**Environmental
Planning
Commission**

**Agenda Number: 08
Project Number: 1007786
Case #: 15 EPC-40053, 54 and 59
November 12, 2015**

Staff Report

Agent	DAC Enterprises
Applicant	Joe Azar II, CCIM
Request	Zone Map Amendment (Zone Change) Site Development Plan for Subdivision Site Development Plan for Building Permit
Legal Description	Tract 2A Indian Ridge Subdivision
Location	Menaul Blvd. NE, between Deanna St and Chelwood Park NE
Size	1.73 acres
Existing Zoning	O-1
Proposed Zoning	SU-1 PRD, maximum 26 units

DRB-1

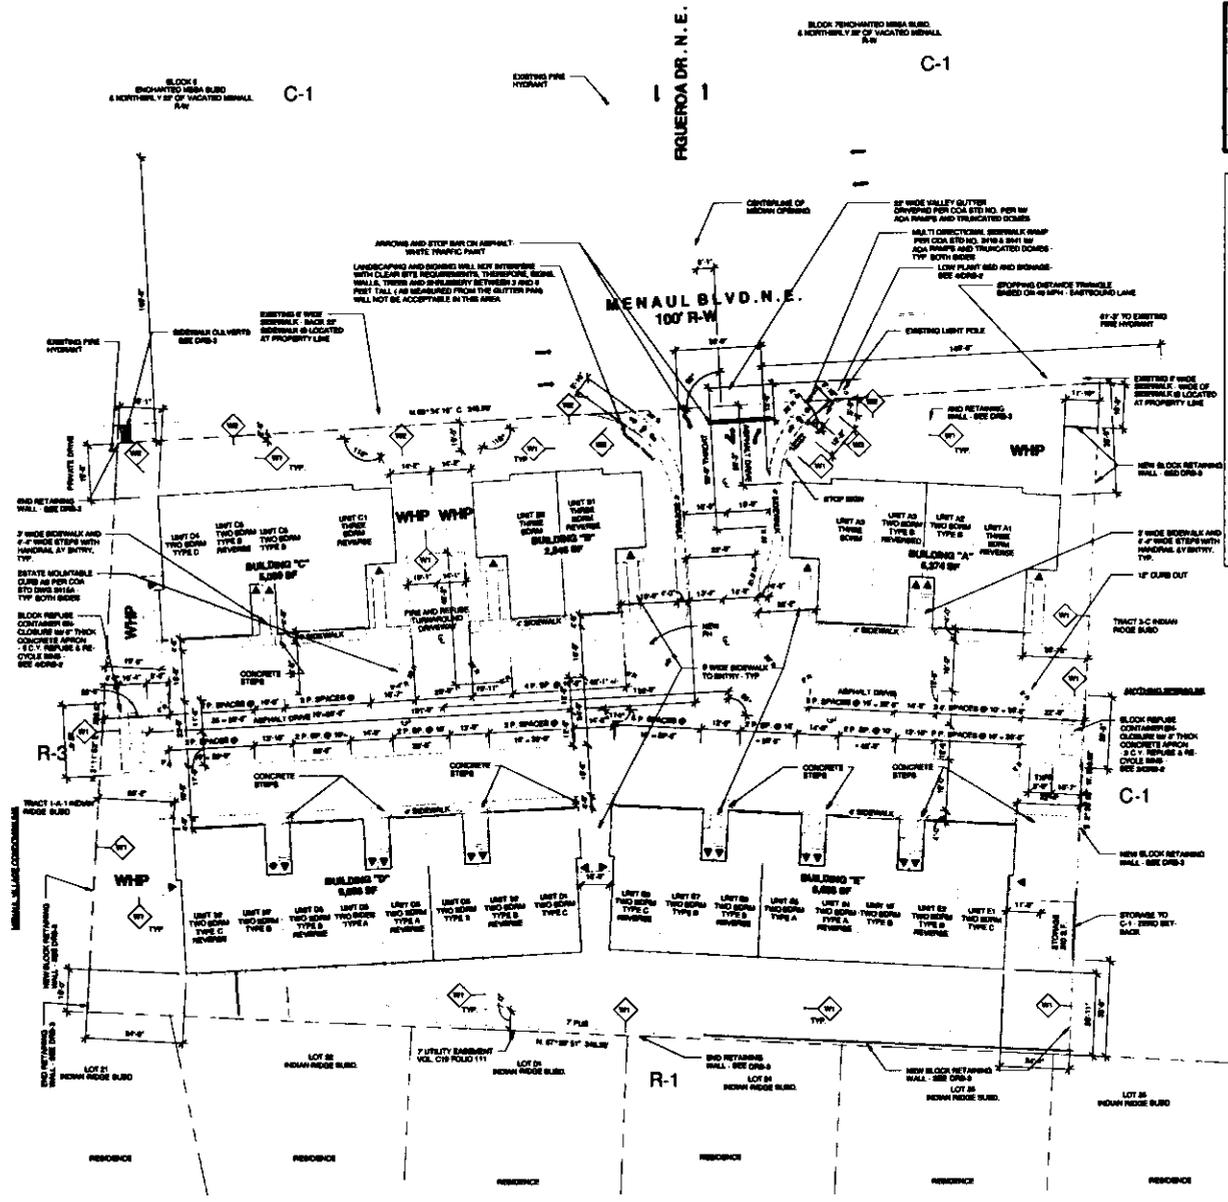
1. An existing overhead electric distribution line is located along the northern western boundary of the site along Menaul NE. It is the applicant's obligation to abide by any conditions or terms of those easements. Sheet DRB-1 should call out the location of the distribution line. Also, the notation of the "existing light pole" implies a street light. The label should be revised to "existing electric power pole." PNM requests a meeting with the applicant to discuss the proximity of the proposed wall in proximity to the existing electric distribution line.
